**9.2 NO. 188 (LOT: 1; D/P: 33790) VINCENT STREET, NORTH PERTH - PROPOSED ALTERATIONS AND ADDITIONS TO PLACE OF WORSHIP**

**PURPOSE OF REPORT:**

To consider an application for development approval for alterations and additions to the Redemptorist Monastery and Church at No. 188 Vincent Street, North Perth (the subject site).

**Drawing No** A401

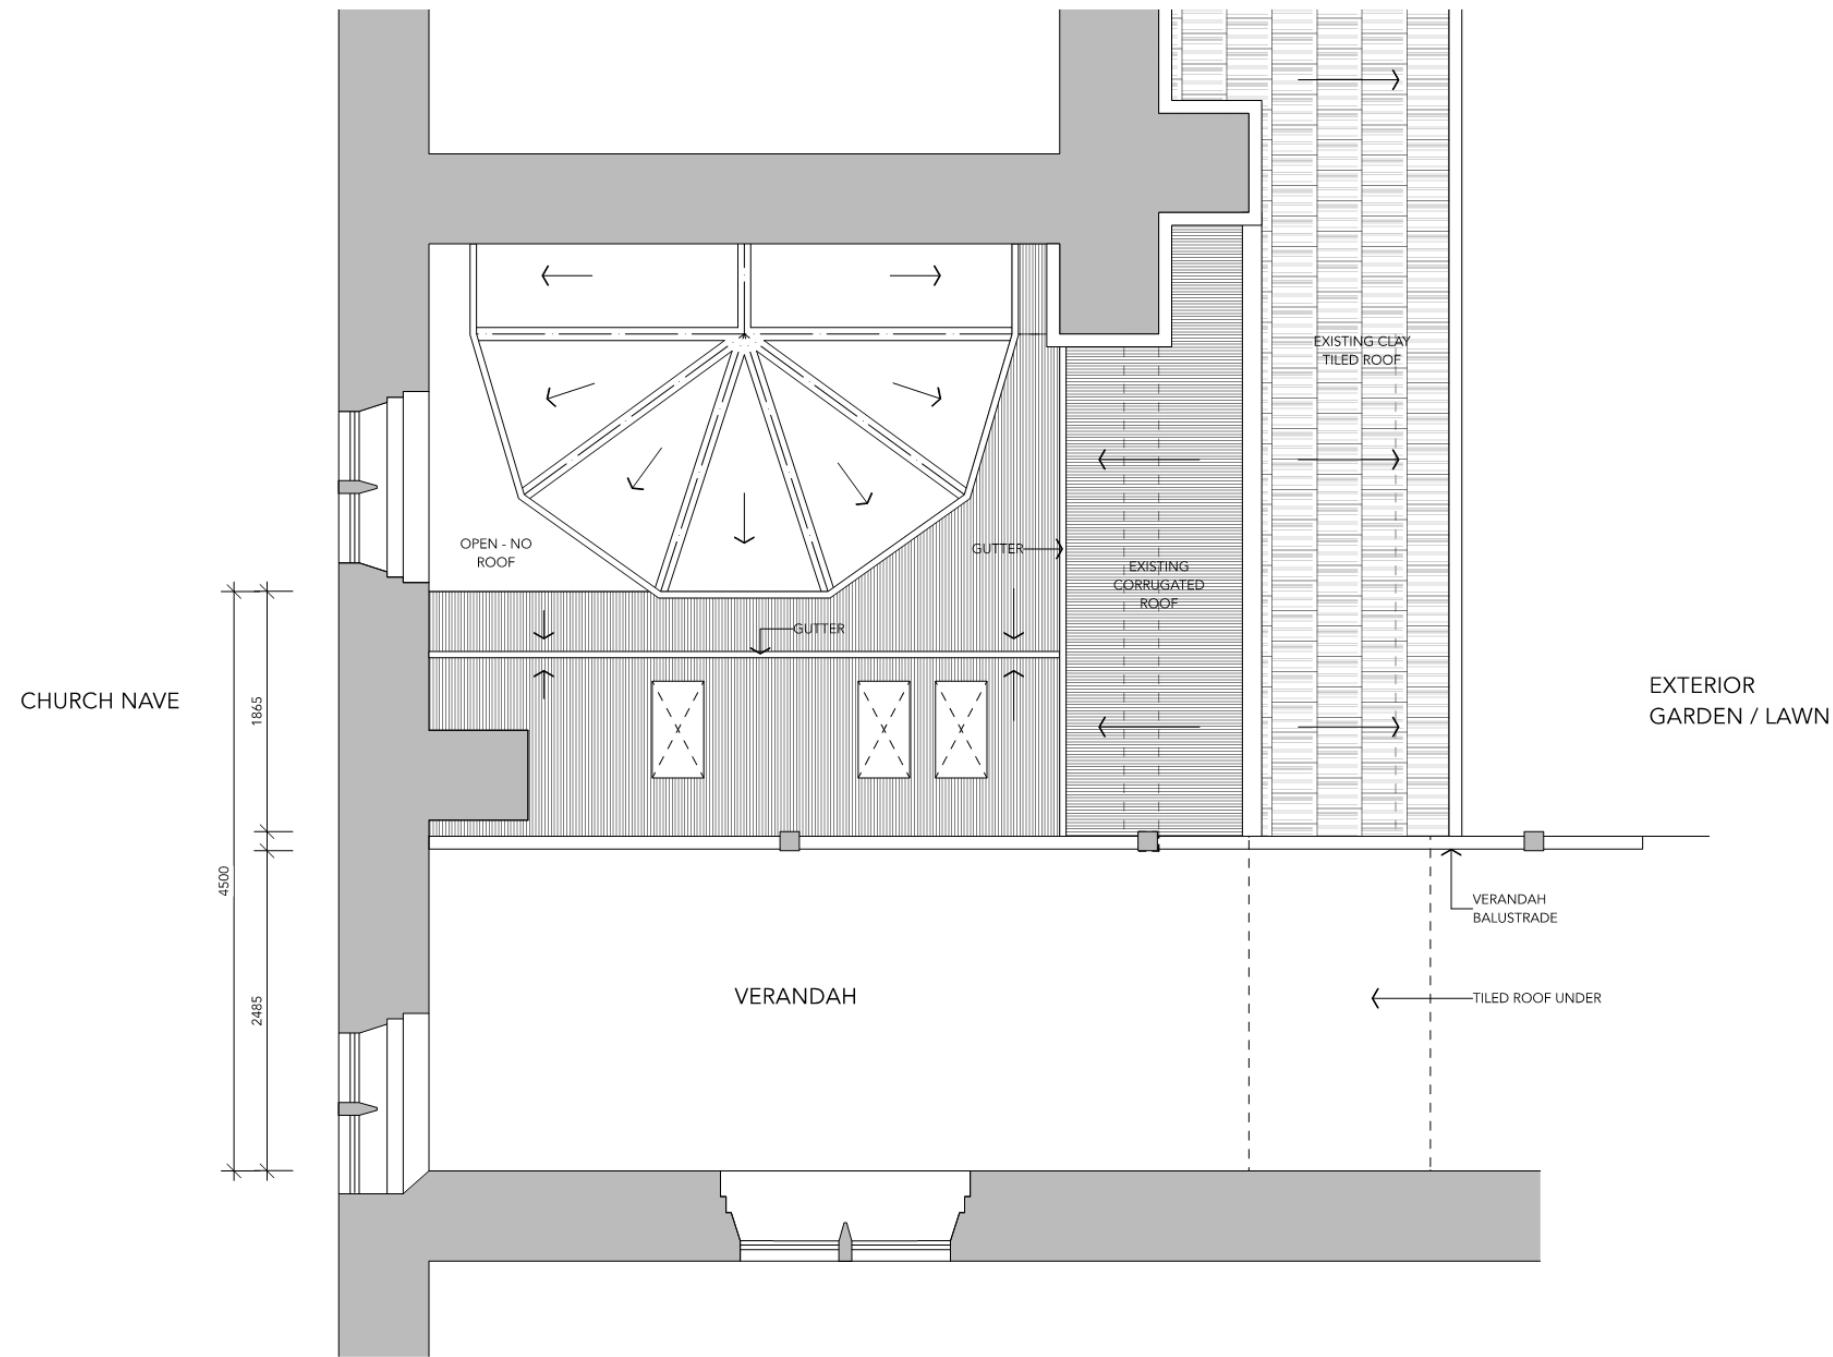
- Glazing to Void: The proposed glazing to the void of the working sacristy would enable the full height of the stained-glass window to be viewed. The glazing would assist in preserving the stained glass and stone fabric of the place by forming an enclosure and protecting these elements from weathering. The proposed glazed void would have minimal aesthetic impact on the heritage place due to the choice of large format glass material with minimal framing;

**Drawing No** **A211**

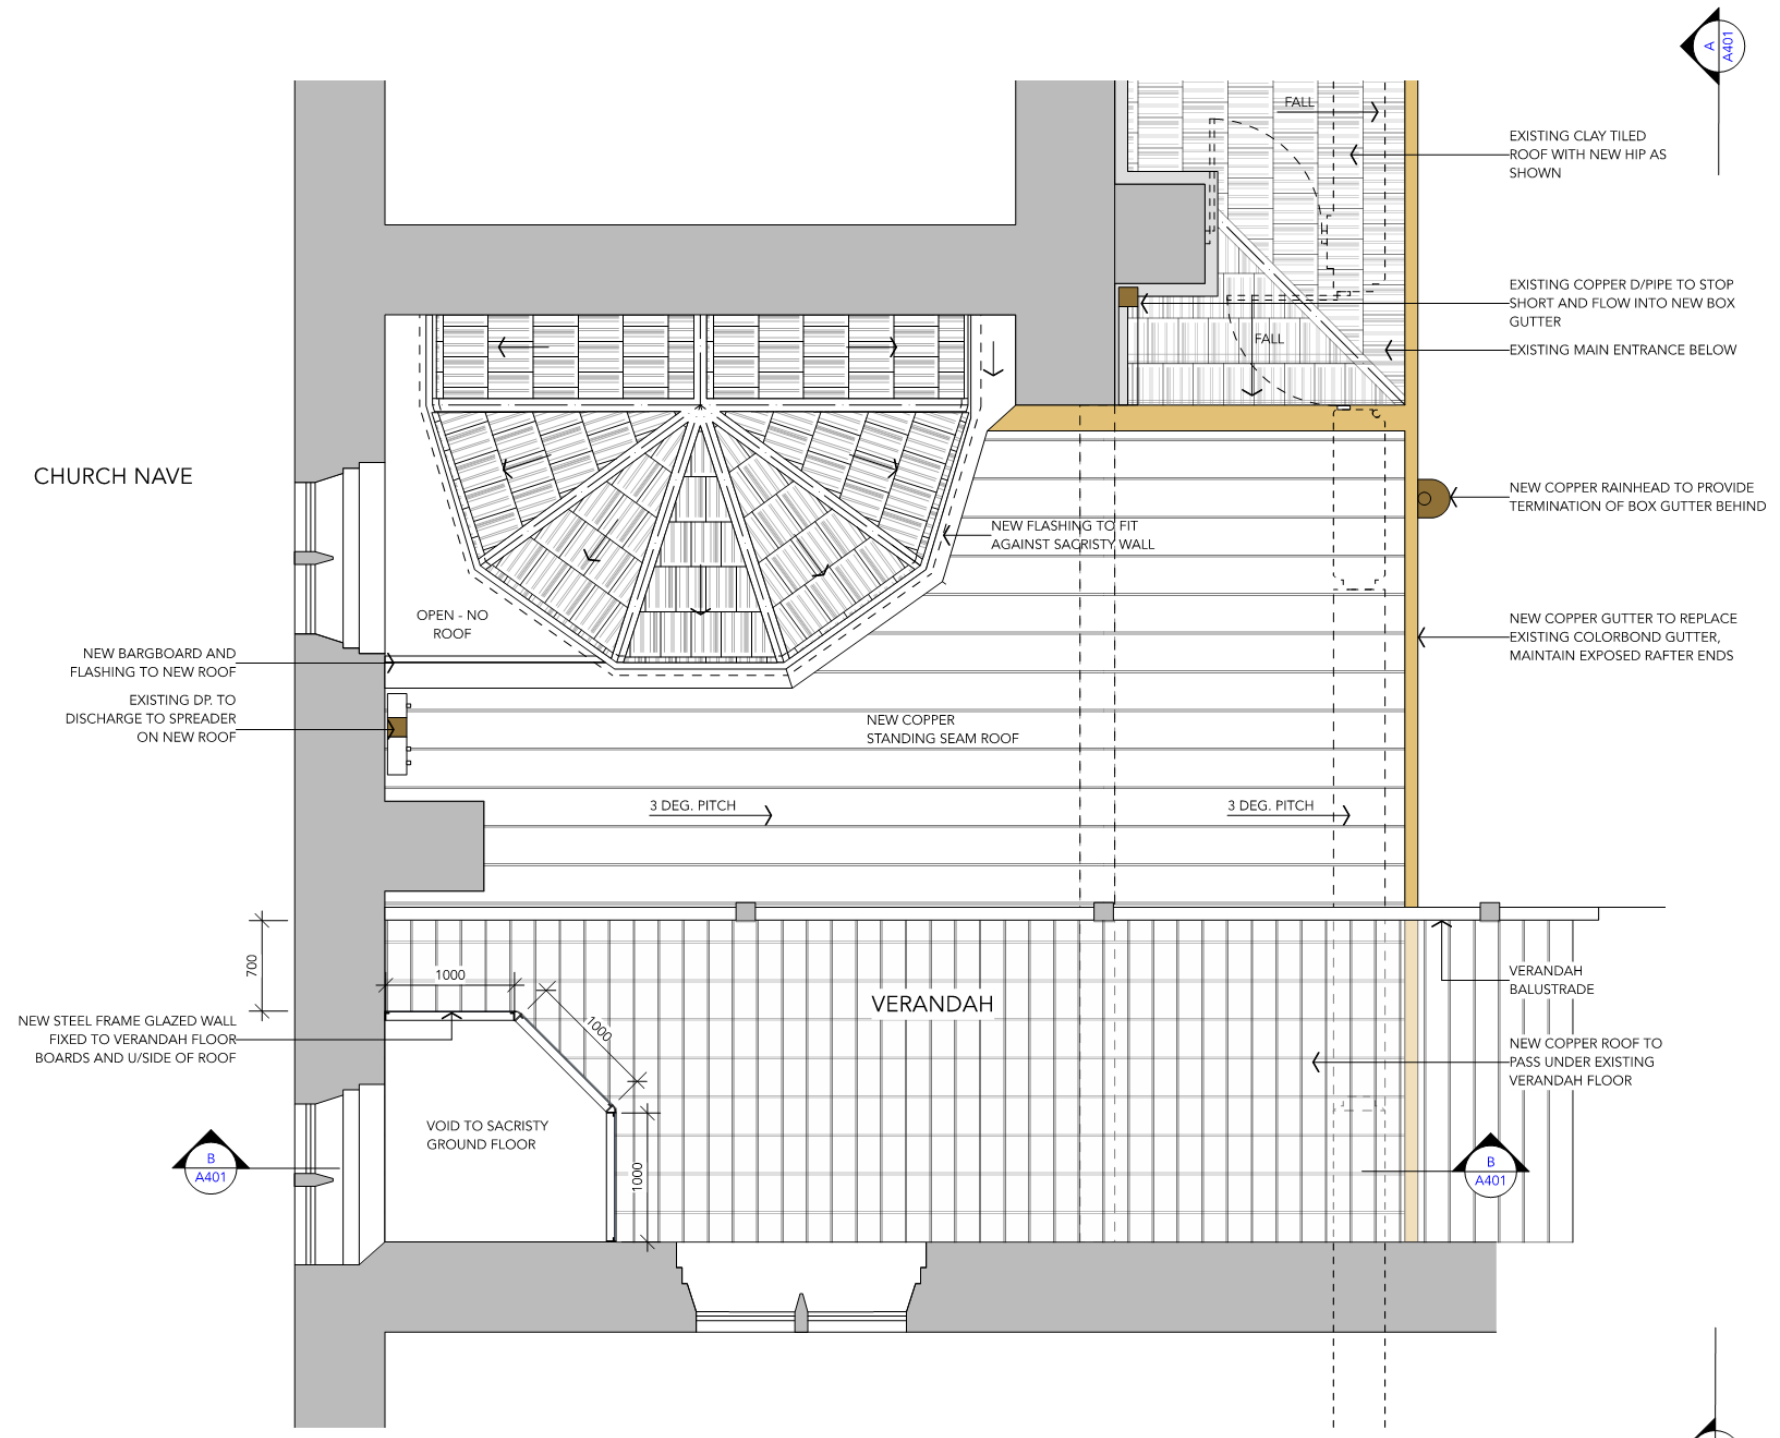
The proposed development complies with all of the acceptable development standards of the Heritage Management Policy, with the exception of the angle of the proposed roof of the Working Sacristy and adjacent corridor.

The proposed development meets all of the acceptable outcome standards of the Built Form Policy, except for the solar absorptance rating of the proposed roof to the working sacristy and adjacent corridor.

- Roof: The replacement of the working sacristy and corridor roof would be acceptable for the following reasons:
  - The replacement of the existing roofs with a skillion roof form would resolve the existing roof drainage issues and enable better management of stormwater on site. The working sacristy was originally an open courtyard. Over time roofing has been added to enclose the space. The working sacristy roof drains to a number of valley gutters and shows evidence of water damage from roof leaks. The simplified roof form would support easier ongoing maintenance conservation of the heritage place;

- Seamed copper is already used on the building, specifically the sacristy. The use of an existing material assists with integrating the roof and the existing building and is sympathetic to the heritage place. The use of copper material is also supported by the DRP member;

- The use of a light colour (<0.4 solar absorptance) material would not be supported in this situation. This is because the colour would not be in keeping with the character of the heritage place and would not assist in integrating the works with the existing building design; and

- The working sacristy is bounded by the church to the west, east transept to the north and the monastery to the south. It cannot be seen from Camelia Street to the east due to the Retreat House and additions to the eastern wing of the monastery in 1912. The modification of the roof form would not affect the existing vistas from adjacent streets and would not affect the aesthetic values of the heritage place; and
